METROPOLITAN GOVERNMENT OF NASHVILLE AND DAVIDSON COUNTY

STAFF RECOMMENDATION
1608 16th Avenue South
April 19, 2017

Application: New construction – addition; Setback determination
District: South Music Row Neighborhood Conservation Zoning Overlay
Council District: 19
Map and Parcel Number: 10408035000
Applicant: Chris Gill
Project Lead: Sean Alexander, sean.alexander@nashville.gov

① WEST ELEVATION
1/8" = 1'-0"

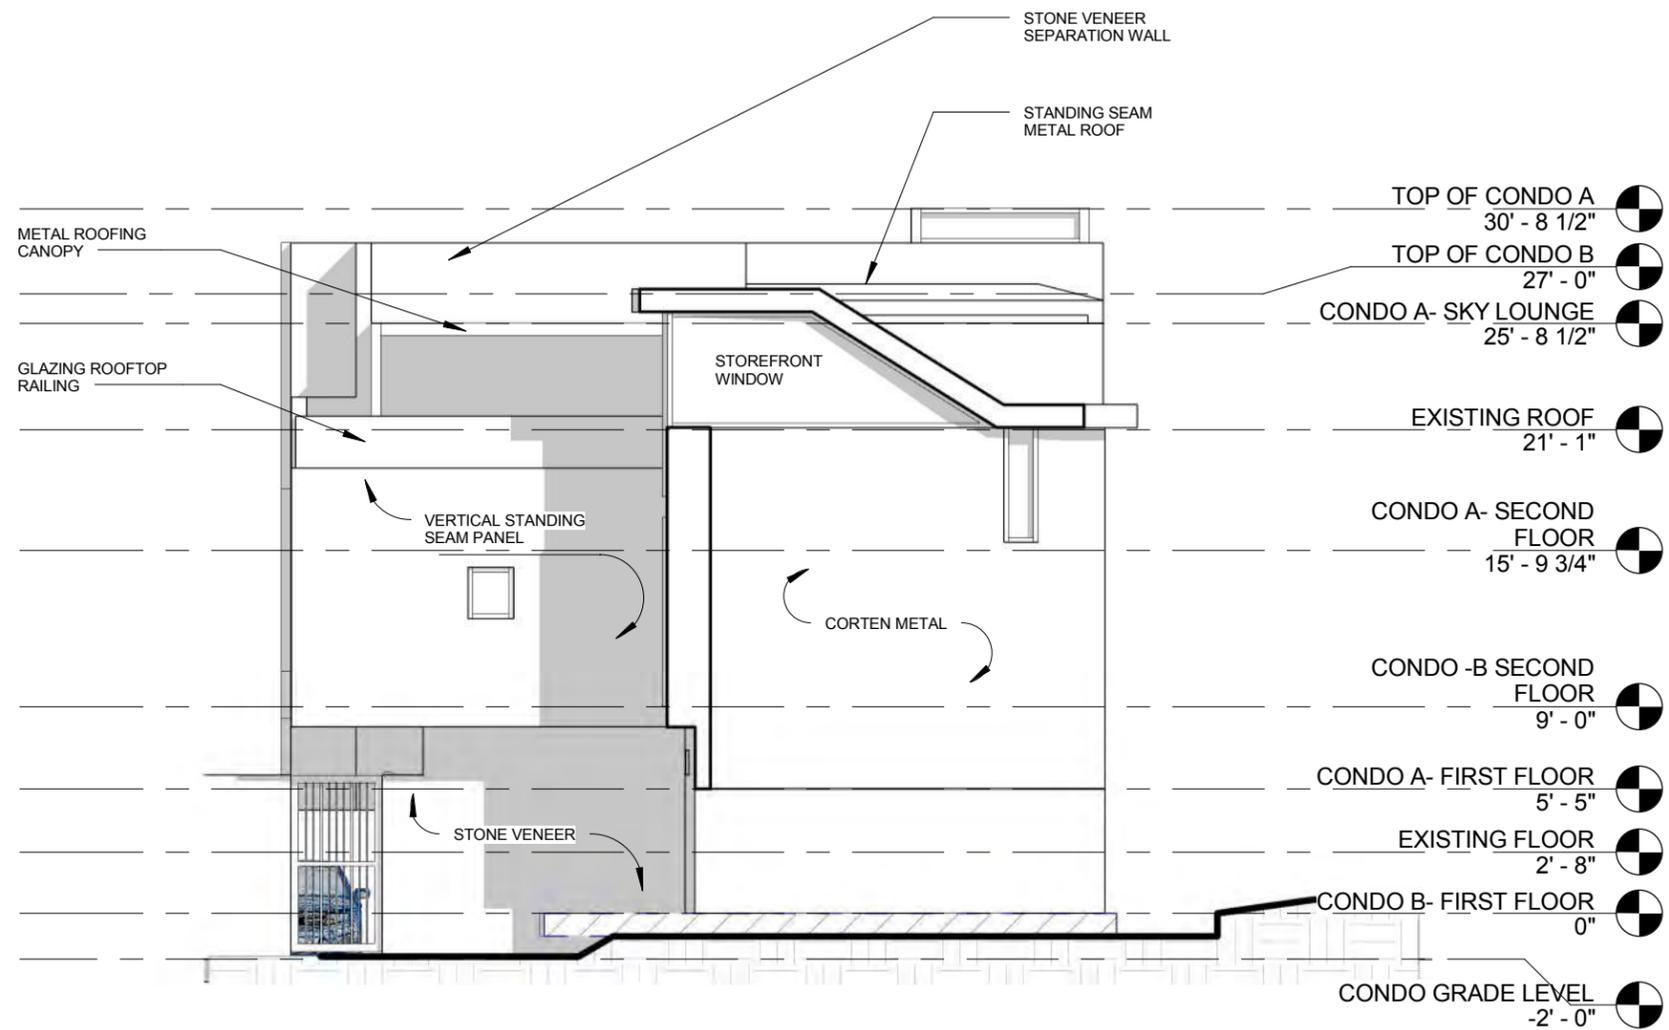
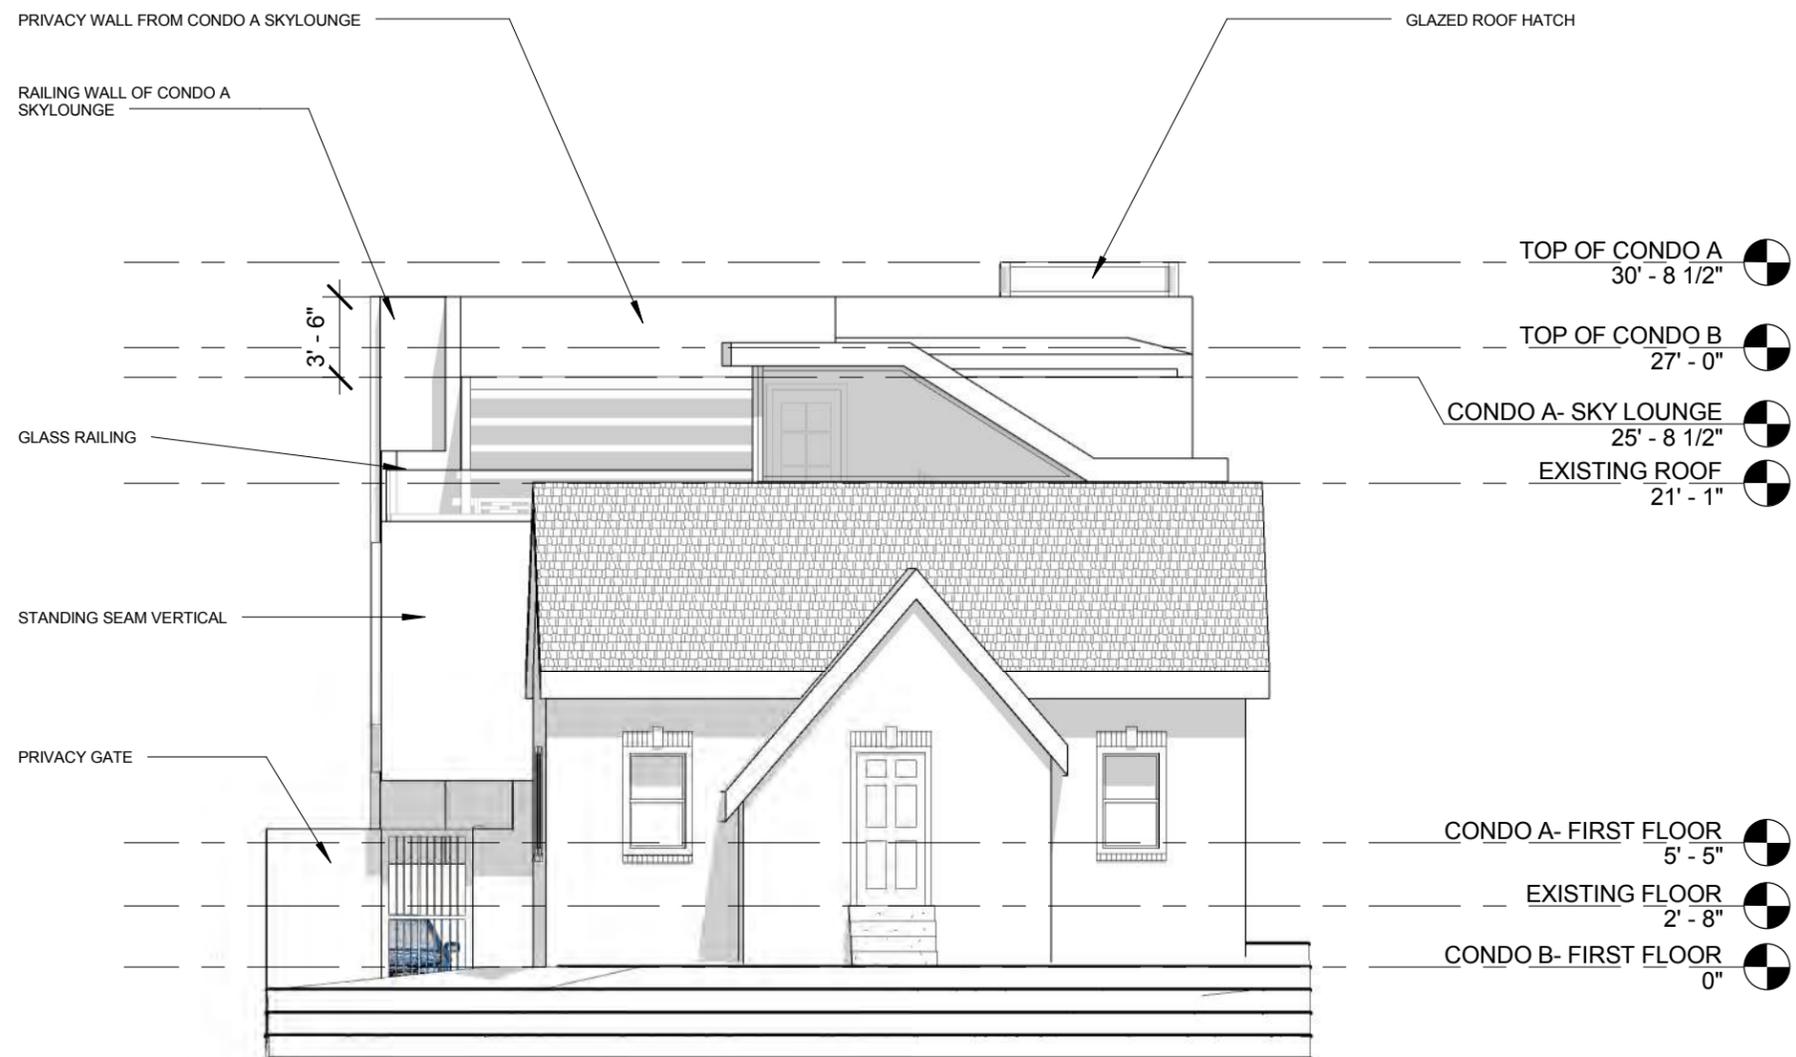
Height, Scale & Building Shape: The addition will have a split-level shape, with two levels in the front unit and two and a half in the rear, with roof decks on both units. The roof of the front unit will be two feet (2') lower than the roof of the house and the roof of the rear unit will be four feet, six inches (4'-6") taller. The taller roof section begins seventy-seven feet (77') back from the front of the building. In addition to the taller roofs the addition will have a stair tower and a railing on the roof deck that extend to six feet (6') and eight feet (8') taller than the original roof, respectively. Additions more than four feet (4') taller than an historic house are generally not considered appropriate; however, in this case Staff finds the proposal to be appropriate because the impact on the

Design: The character of the addition is contemporary and would not be mistaken for an original part of the building. The addition's primary roofs will be flat, and the proportions of windows will be larger and more square than those of the historic houses. Although the form of the addition is not typical of nearby historic buildings, Staff finds the addition to be appropriate given the minimal physical impact it will have on the historic building, and its location at the rear of the lot approximately ninety feet (90') to one hundred, thirty feet (130') from the street. For these reasons, and because of the

Roof form: The addition will have tiered sections rising to the rear, with the majority of the sections having flat roofs. Although flat roofs are not typical of historic buildings in the area, Staff finds the addition to be appropriate given the minimal physical impact it will have on the historic building, and its location at the rear of the lot approximately ninety feet (90') to one hundred, thirty feet (130') from the street. In addition, the district has several low-sloped hipped roofs that from the street, can take on a flat-roof appearance. For these reasons, and because of the unique historical character of the South Music Row district, Staff finds the project to be appropriate and to meet section II.B.1.d of the design guidelines.

Proportion and Rhythm of Openings: The windows on the proposed addition do not have the proportions and patterns typical of historic buildings nearby, particularly on the left side where windows comprise roughly half of the wall space. The windows on the right side are more like that of historic windows in their placement, but the sizes are also not typical of historic houses. No changes to the window and door openings on the existing house are planned.

Recommendation: Staff recommends approval of the proposed addition to the contributing building at 1608 16th Avenue South with the condition that the stone, metal, concrete, and window and door selections are approved by MHZC Staff prior to purchase and installation. Given the unique historical character of the area, Staff finds the project would be appropriate and meet the design guidelines for the South Music Row Neighborhood Conservation Zoning Overlay.
